V2500-A5 SERIES PROPULSION SYSTEMS SERVICE BULLETIN

This document transmits Revision 1 to Service Bulletin EV2500-72-0535

V2500-ENG-72-0535

ENGINE – COMPRESSOR NON MODULAR – INTRODUCTION OF A CABLE FEED – THROUGH ADAPTER FOR
THE FUEL LACQUER AND TEMPERATURE SURVEY INVESTIGATION

Installation of the Instrumentation Adapter (72-38-25, 01-290)
Figure 1

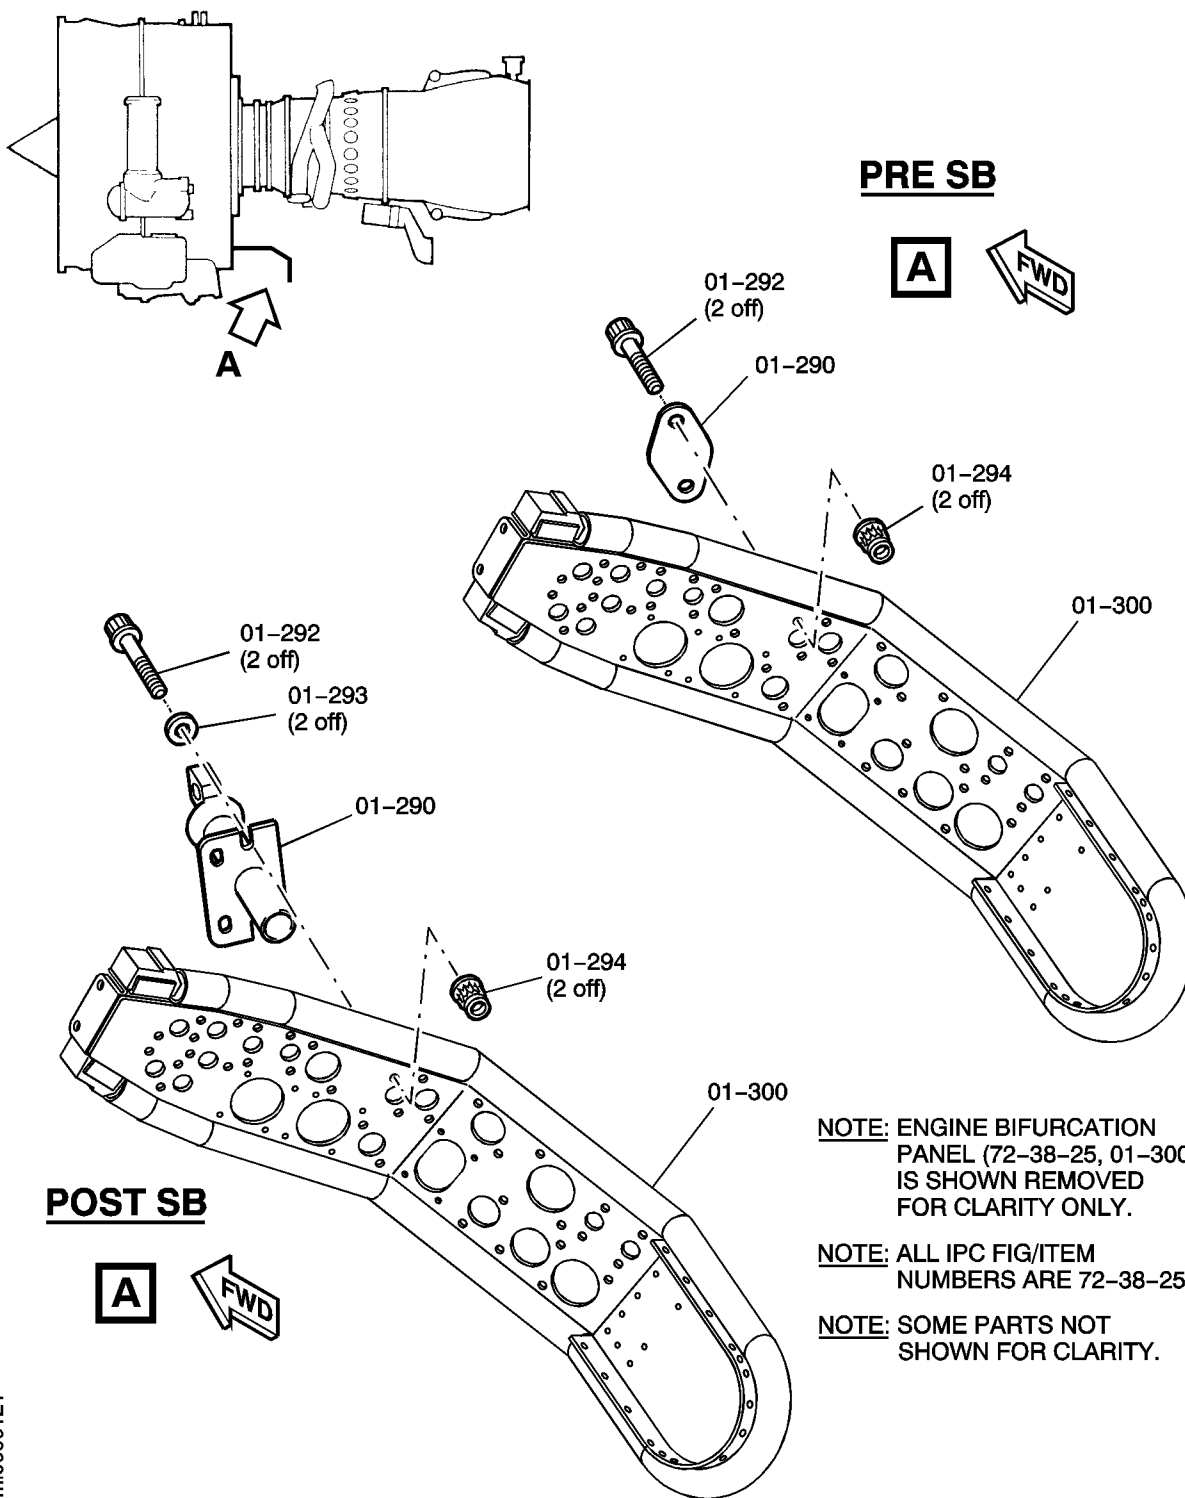
- (3) Replace the cover with the instrumentation adapter (Refer to Figure 1)
- (a) Remove the blanking plate (72-38-25, 01-290)
- (i) Remove the two nuts (72-38-25, 01-294) and the two old bolts (72-38-25, 01-292), P/N 4W0163 that attach the blanking plate (72-38-25, 01-290) to the engine bifurcation panel (72-38-25, 01-300).

- (ii) Remove the old blanking plate (72-38-25, 01-290), P/N LK62478 from the engine bifurcation panel (72-38-25, 01-300).
- (b) Install the instrumentation adapter (72-38-25, 01-290)

- (i) Clean the mating surfaces of the instrumentation adapter (72-38-25, 01-290) and the engine bifurcation panel (72-38-25, 01-300). Use a clean cloth made moist with acetone (Material No. V01-031).

- (ii) Apply a thin layer of cold curing silicone compound (Material No. V08-013) to the mating surface of the instrumentation adapter (72-38-25, 01-290).

- (iii) Feed the thermocouple wire bundle through the orifice at the now vacant position in the engine bifurcation panel (72-38-25, 01-300) (Refer to Flight Test Modification Bulletin FTMB 5011).

- (iv) Install the new instrumentation adapter (72-38-25, 01-290), P/N 6A9099 to the engine bifurcation panel (72-38-25, 01-300).
- (v) Apply a thin layer of engine oil (Material No. V10-077) to the threads of the two new bolts (72-38-25, 01-292), P/N 4W0165 and the two nuts (72-38-25, 01-294).

- (vi) Install the two new bolts (72-38-25, 01-292), P/N 4W0165, the two new washers (72-38-25, 01-293), P/N 4W2622 and the two nuts (72-38-25, 01-294) that attach the instrumentation adapter (72-38-25, 01-290) to the engine bifurcation panel (72-38-25, 01-300).

- (vii) Torque the two nuts (72-38-25, 01-294) to between 85 and 105 lbf in. (10 and 12 Nm).
- (viii) Remove any unwanted sealant compound from the joint area. Use a clean cloth made moist with acetone (Material No. V01-031).
